TRANS/WP.29/GRSP/2001/20
11 September 2001

PROPOSAL FOR DRAFT AMENDMENTS TO REGULATION No. 17

(Strength of seats)

Transmitted by the Expert from the Czech Republic

The figure, amend, to read:

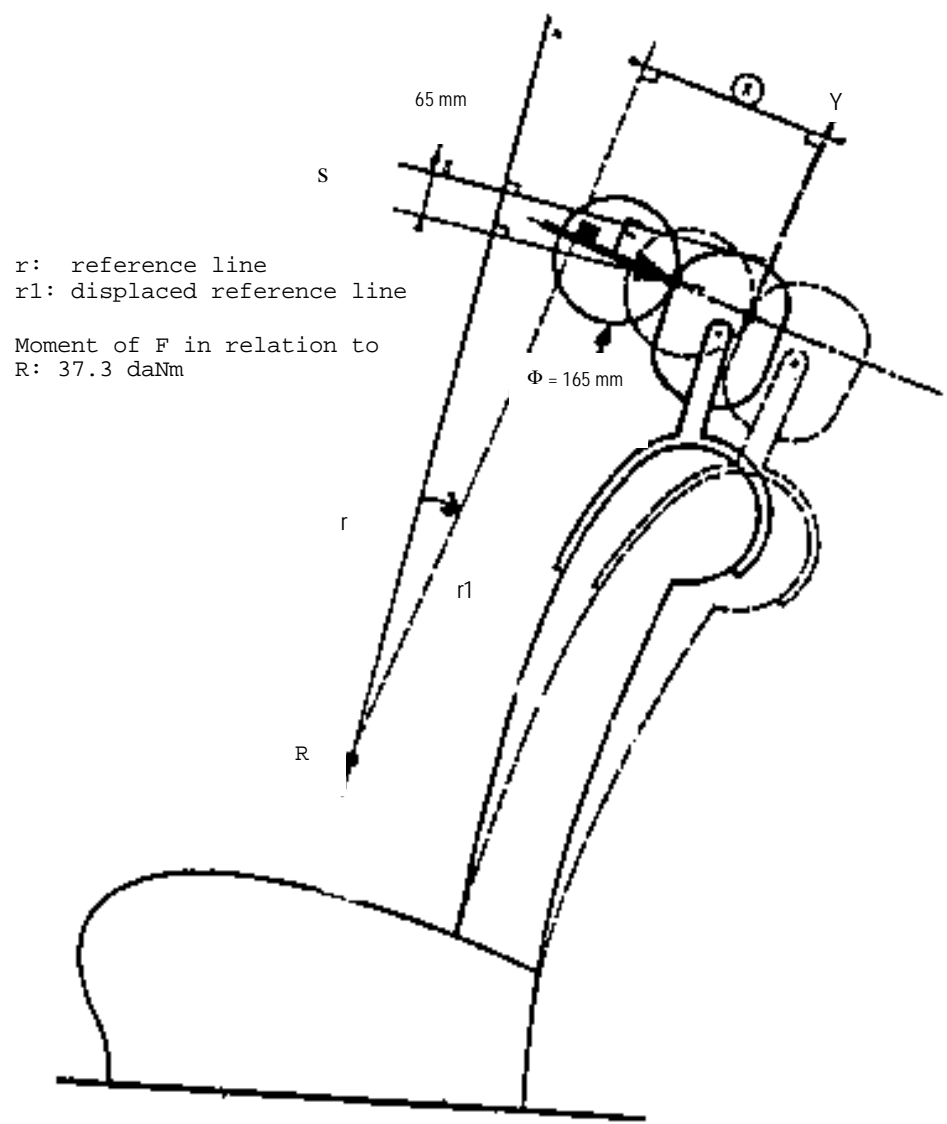
Annex 5,

r: reference line
r1: displaced reference line

Moment of F in relation to
R: 37.3 daNm

————— Initial period - - - - - position under load "

The figure shall be amended to bring it in compliance with the relevant prescription in the text as follows:

- (a) the **radius of the sphere** $165/2=82.5$ mm shall be diagrammed greater than the distance 65 mm,
- (b) the **displaced position of head restraint** under loading force **F** shall be given by its rotation around the point **R**,
- (c) the **measured deformation "x"** shall be given by the distance of two parallel lines: the displaced reference line **r₁** and the tangent **Y** in contact "sphere-restraint".
